RE: Submission to HumeLink Contingent Project Application Stage 2 application

The Centre for Independent Studies (CIS) welcomes the opportunity to respond to Transgrid's Contingent Project Application Stage 2 (CPA2) application for HumeLink.

Figure 1. Timeline of events surrounding the MCCA

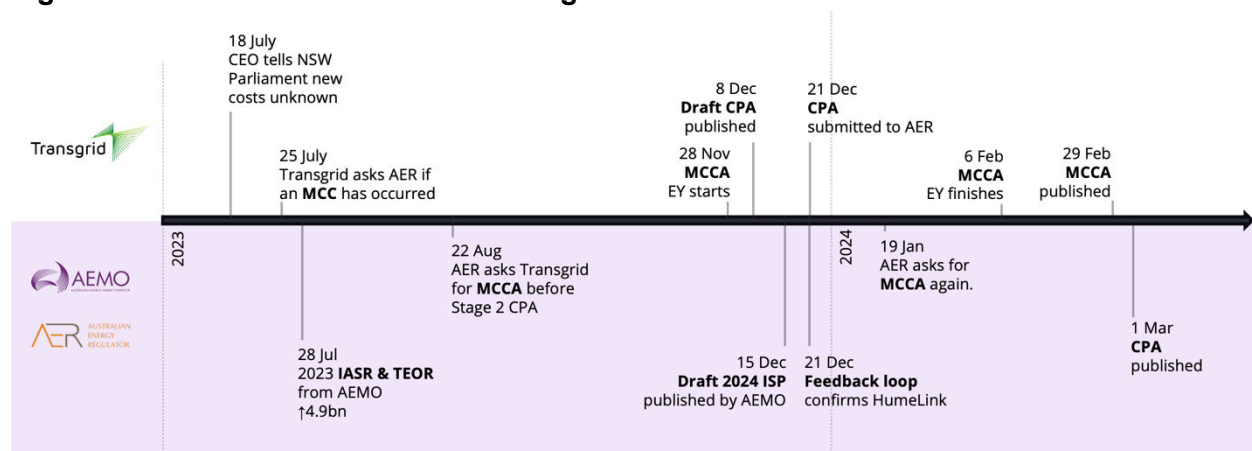
Despite this, Transgrid completed their MCCA on 29 February 2024, nearly six months later. In addition, they submitted their Stage 2 CPA on 21 December 2023, 70 days prior to completing the MCCA; directly contradicting AER's directive that the NER required Transgrid to supply evidence of the MCCA prior to a CPA. This led AER to issue another notice to Transgrid on 19 January 2024, warning that the CPA is at risk of being non-compliant for not lodging the MCCA before submitting the Stage 2 application.¹⁸

Figure 2. Successive changes in HumeLink’s Step Change scenario NPV²⁶

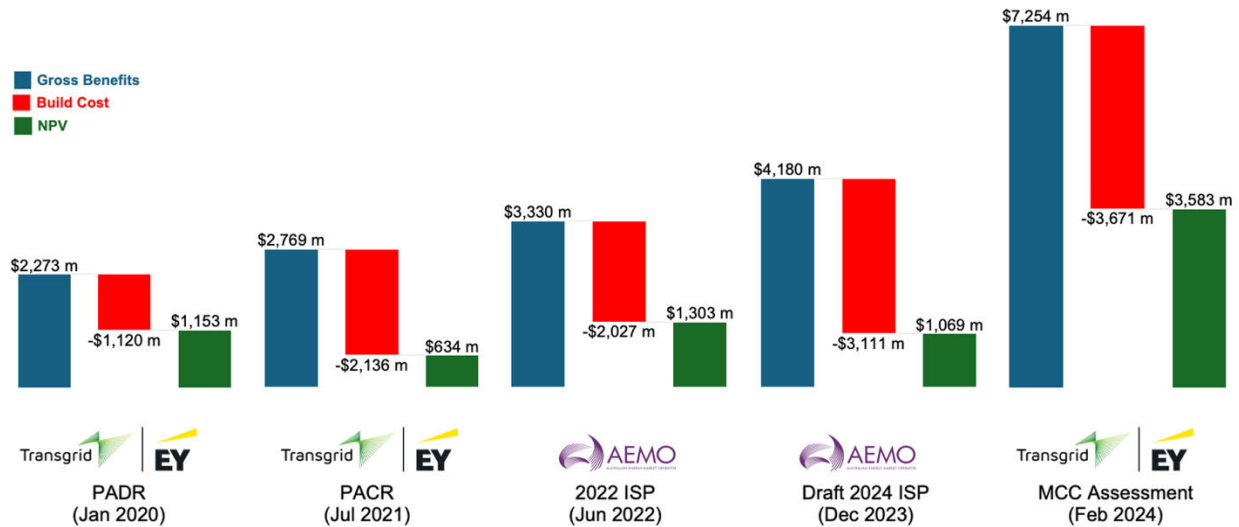
The 7.7x increase in NPV to \$3.58b under Transgrid's revised estimates is therefore a shock. It is also more than triple the \$1.07b NPV estimated by AEMO in the Draft 2024 ISP via the 'TOOT' analysis.²⁴ As EY notes in their Gross Market Benefit Assessment of Humelink, the significant difference in net economic benefits cannot simply be attributed to "the three-year difference in commissioning date and outlook period"²⁵ from the Draft 2024 ISP.

EY’s Gross Market Benefit Assessment of HumeLink estimates a total discounted market benefit of \$7.25b, 74% more than the Draft 2024 ISP, and 161% more than the same model in the PACR. This significant change brings into question the reliability of the entire assessment.

Figure 3. Revised MCC capex cost estimates for the three options compared to the cost estimates in the PACR Addendum

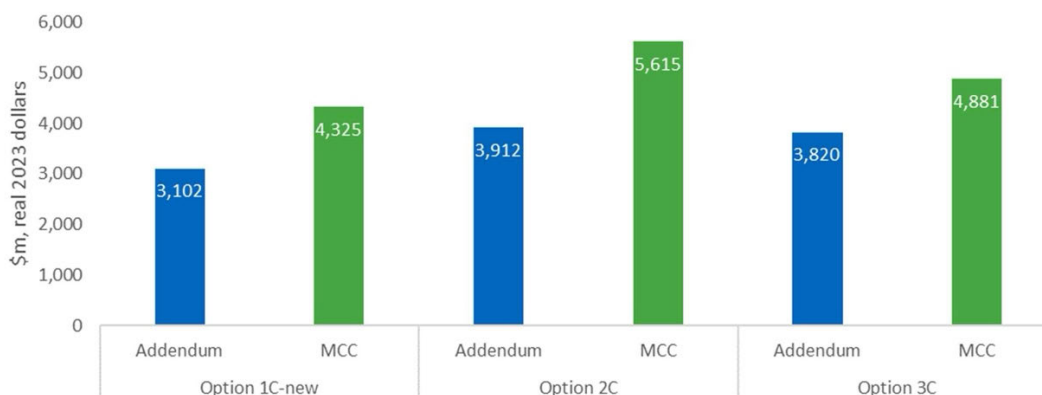
The capital expenditure costs for Option 1C-new and Option 2C have both seen a significant increase since the PACR — 39% (\$1,223 million) and 44% (\$1,703 million) respectively — whereas the cost for Option 3C has risen by a lesser extent: only 28% (\$1,061 million). Given that Option 3C includes everything from Option 1C-new plus the additional stretch from Wondalga to Wagga Wagga, it raises questions as to why its cost increase is \$162 million lower than that of Option 1C-new.
